Access Compliance Report

(Curb Ramps)

Intersection ID: 10029240	Main Street: JOHNSTON_RD	Cross Street: N/A	Location: E
ADA ID: B48299CB7419	Ramp Type: PerpDiag	Initial Pass/Fail: Fail	Overall Compliance: No
Severity Score: 17.5			
Codes/Mitigation Info/Possible Solution		Field Measurements/Component Compliance

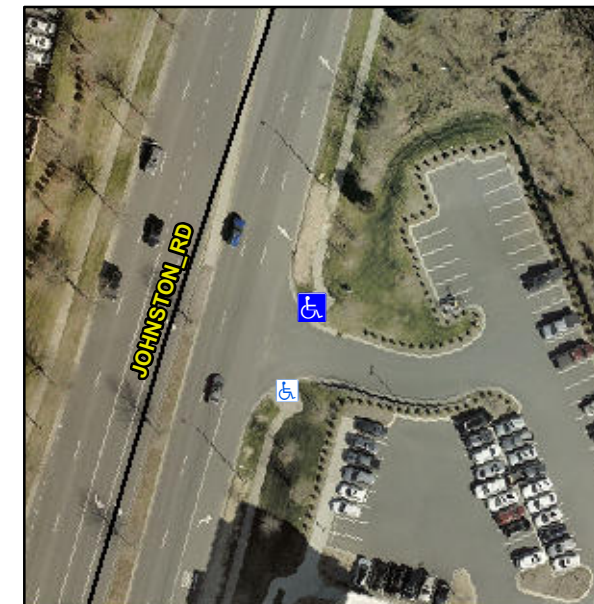
Compliance	Description	Data	Compliance	Description	Data
N/A	Ramp Length (in)	118.0	Yes	Ramp Slope (%)	5.5
No	Ramp Width (in)	33.0	Yes	Ramp XSlope (%)	0.9
N/A	Flare Type LT	N/A	N/A	Flare Type RT	N/A
N/A	Flare Slope LT (%)	N/A	N/A	Flare Slope RT (%)	N/A
N/A	Flare Traversable LT?	N/A	N/A	Flare Traversable RT?	N/A
N/A	Landing Length (in)	N/A	N/A	DWS Provided?	N/A
N/A	Landing Width (in)	N/A	N/A	DWS Contrast?	N/A
N/A	Landing Slope (%)	N/A	N/A	DWS Length (in)	N/A
N/A	Landing X Slope (%)	N/A	N/A	DWS Full Width?	N/A
N/A	Landing Curb? (Y/N)	N/A	N/A	DWS Offset (in)	N/A
N/A	Shared Landing?	N/A			
N/A	Gutter Ponding?	N/A	N/A	Gutter Slope (%)	N/A
N/A	Gutter Lip Ht (in)	N/A	N/A	Gutter X Slope (%)	N/A
N/A	Painted X Walk1?	No	N/A	Painted X Walk2?	No
	X Walk 1 Direction	To NW		X Walk 2 Direction	To SW
N/A	X Walk 1 Width (in)	N/A	N/A	X Walk 2 Width (in)	N/A
	X Walk 1 Slope (%)	0.5		X Walk 2 Slope (%)	0.9
	X Walk 1 X Slope (%)	1.9		X Walk 2 X Slope (%)	2.4

Remove & Replace Curb Ramp With Two New Directional Ramps or Equivalent.
